Architect's Supplemental Instructions

Architect's ASI No: 063

Project:
Webster University
Interdisciplinary Science
Building

Date Issued: 04/21/17

A0202

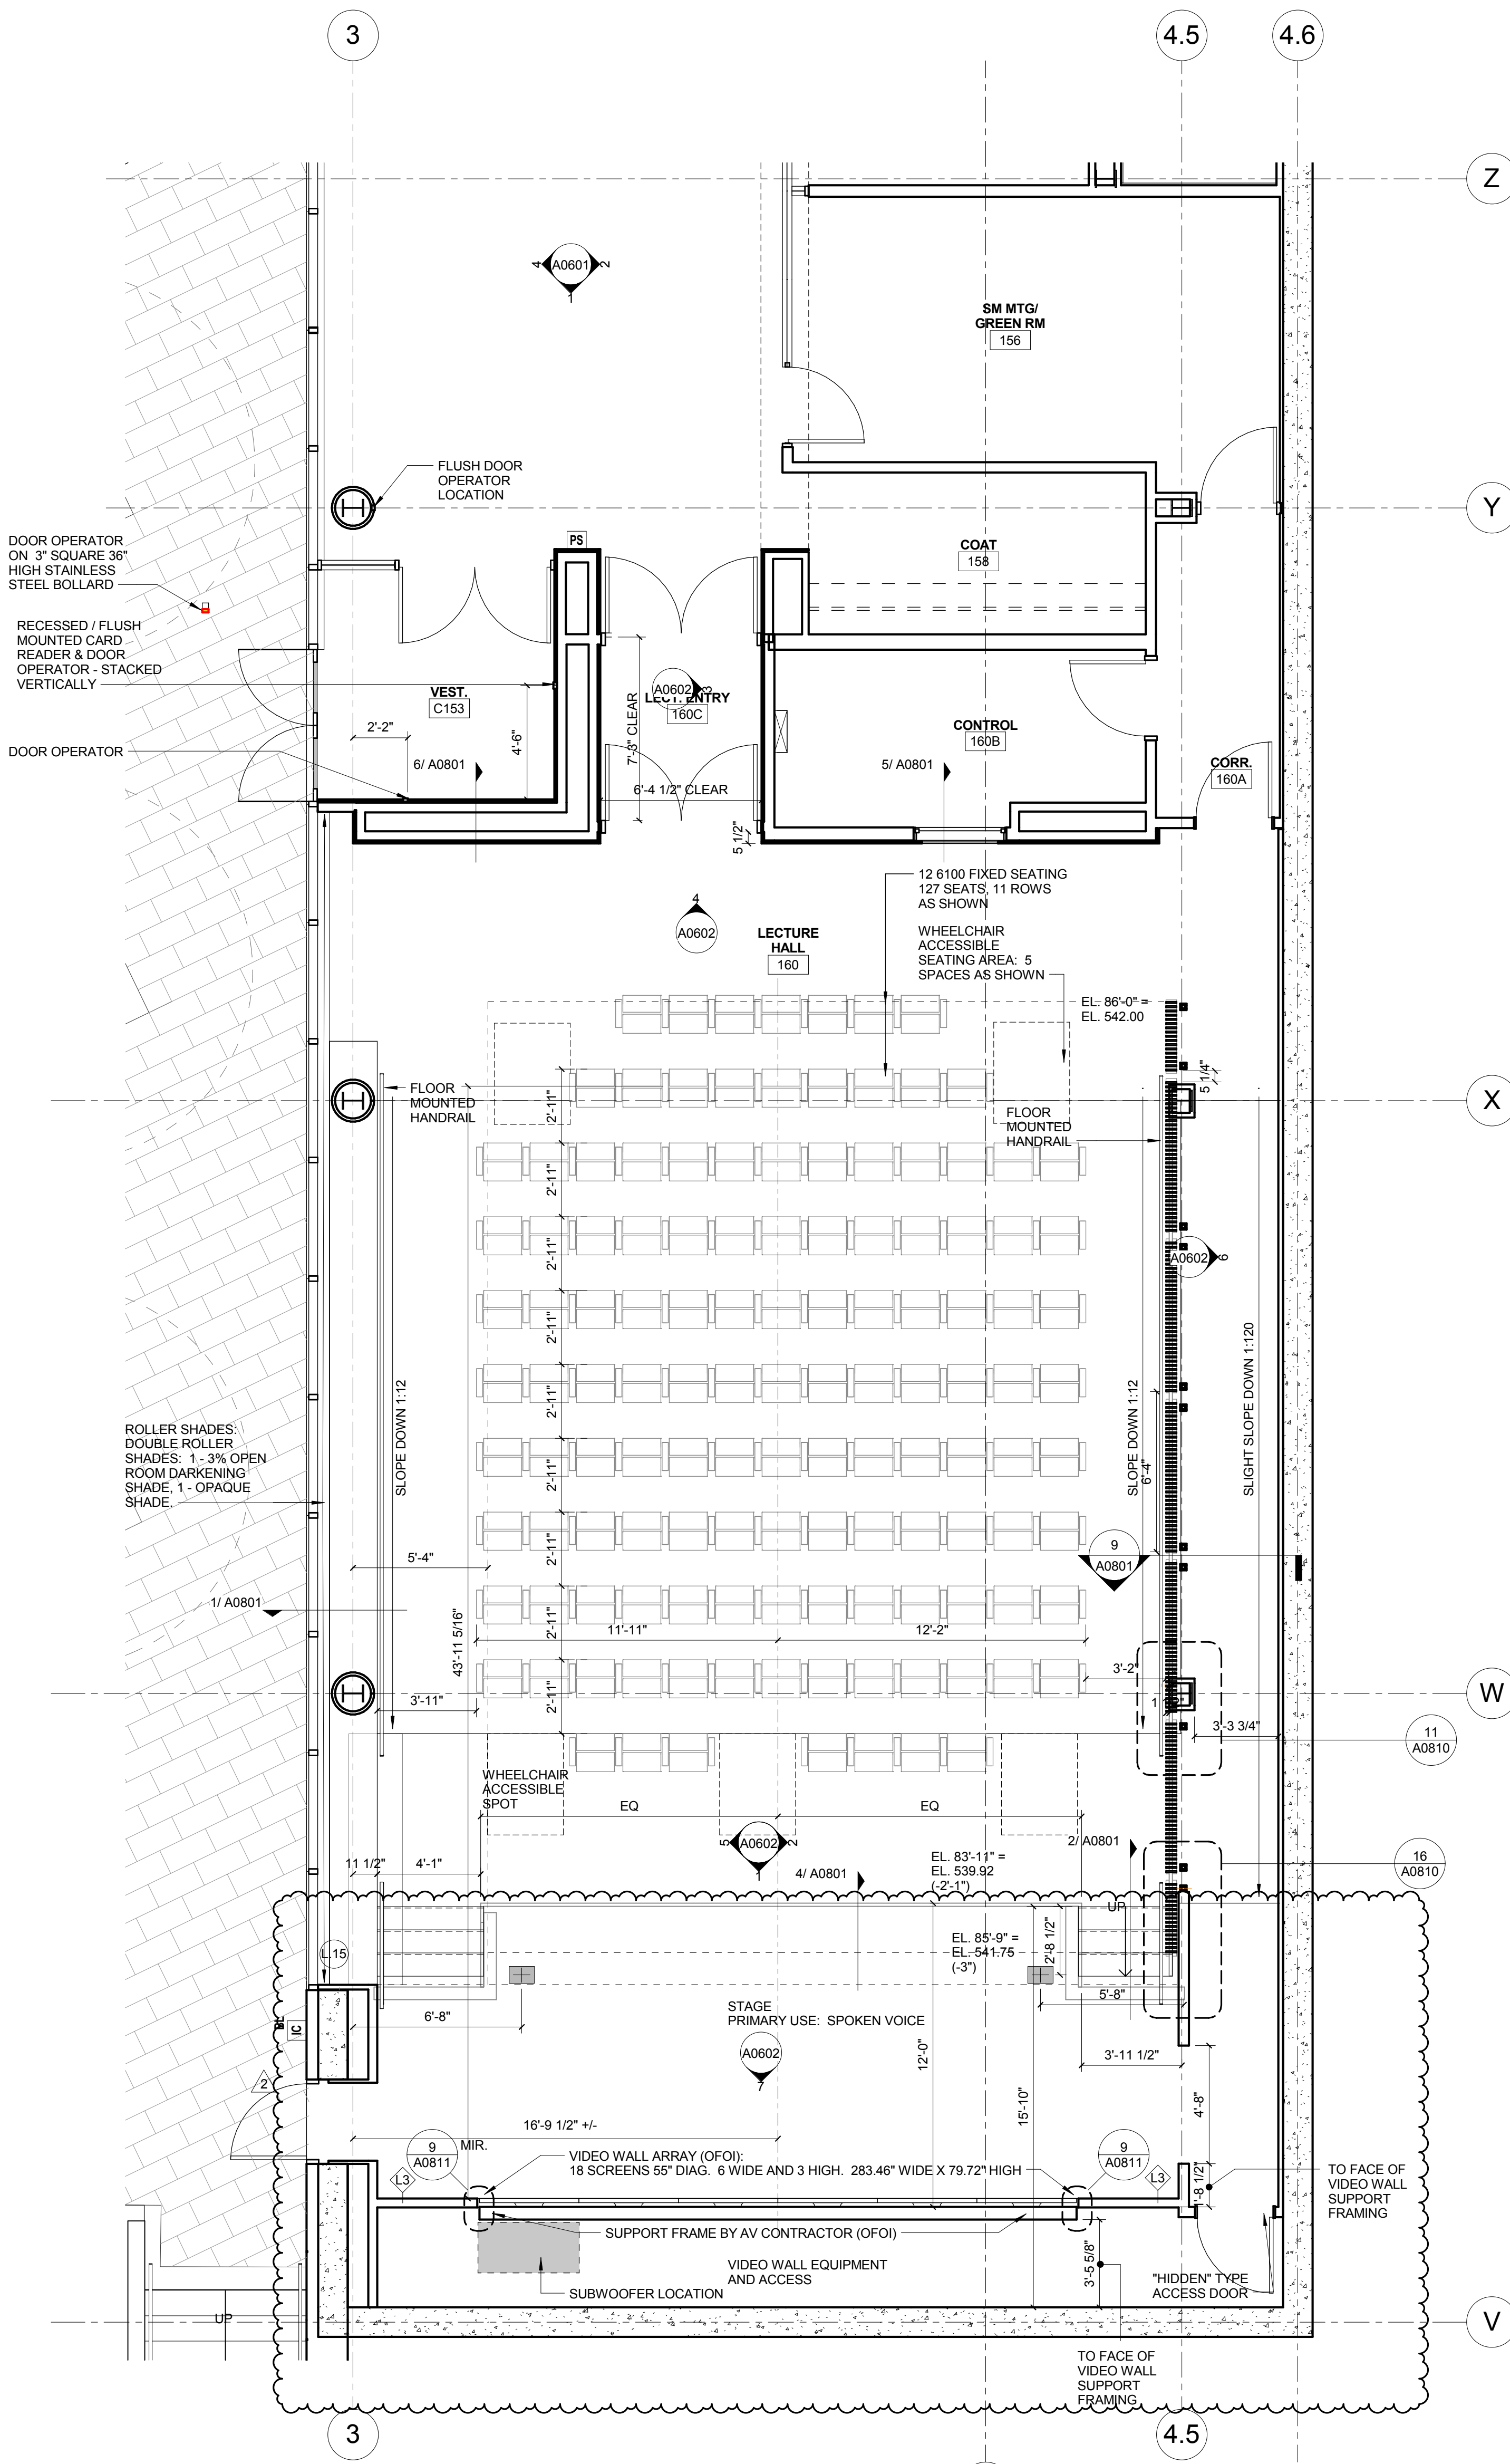
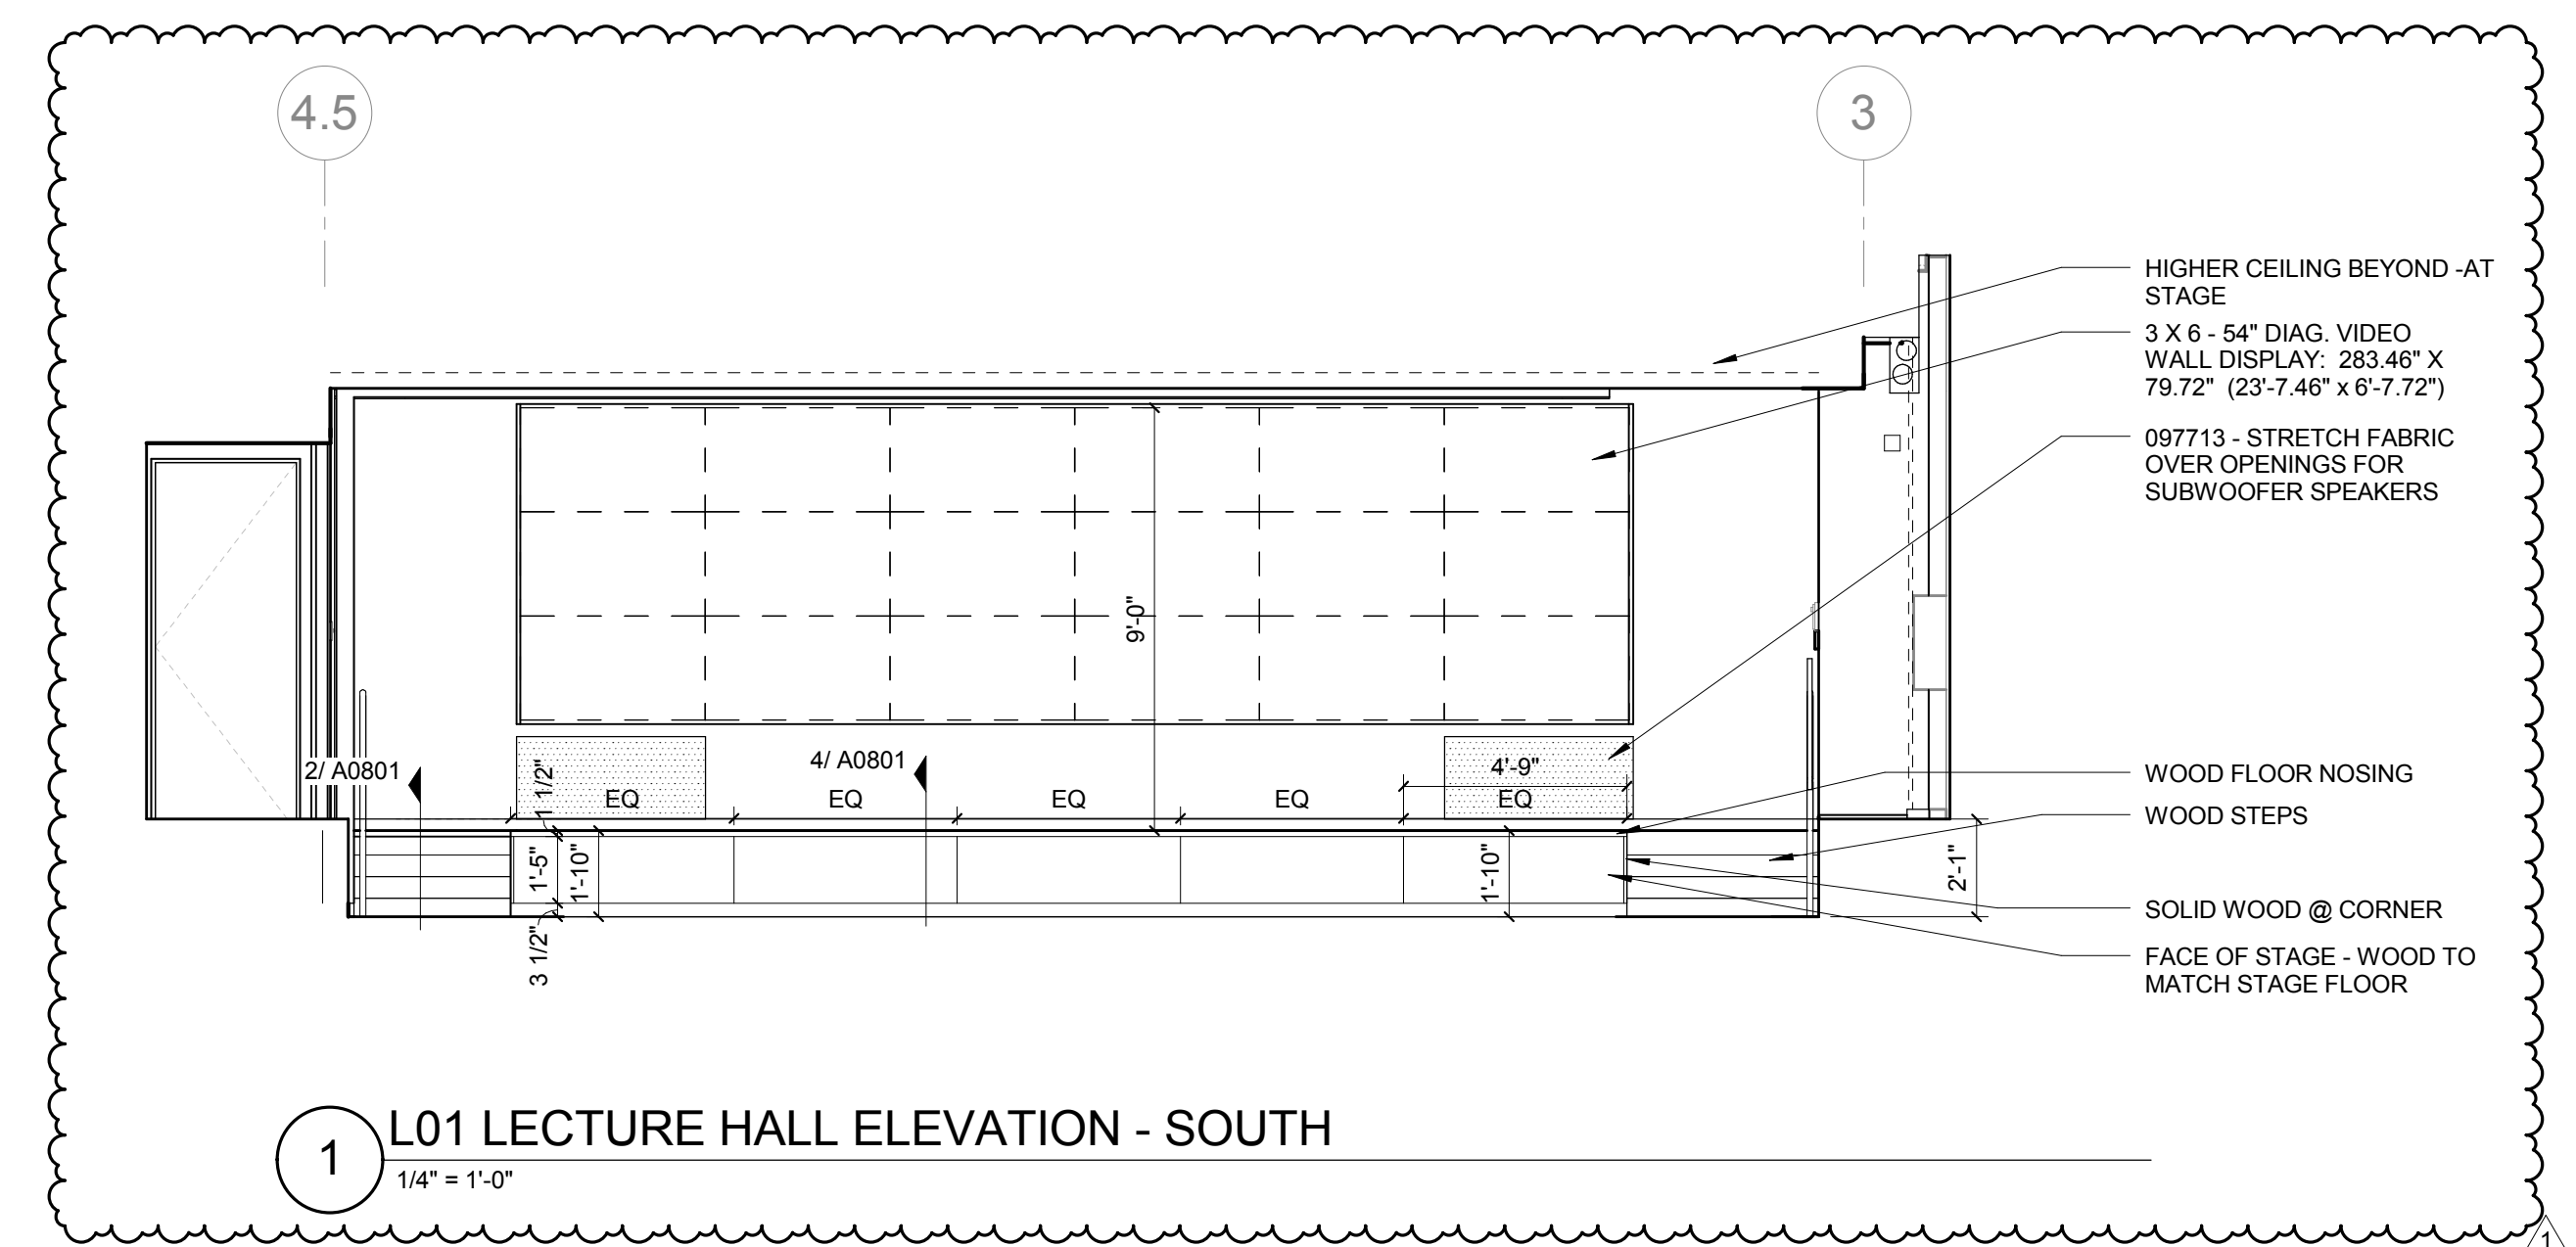
- Revised partition layout and details to accommodate revised Video wall selection per AV drawings.
- Added ceiling mounted curtain tracks in room 131 HEALTH ASSESSMENT LAB.
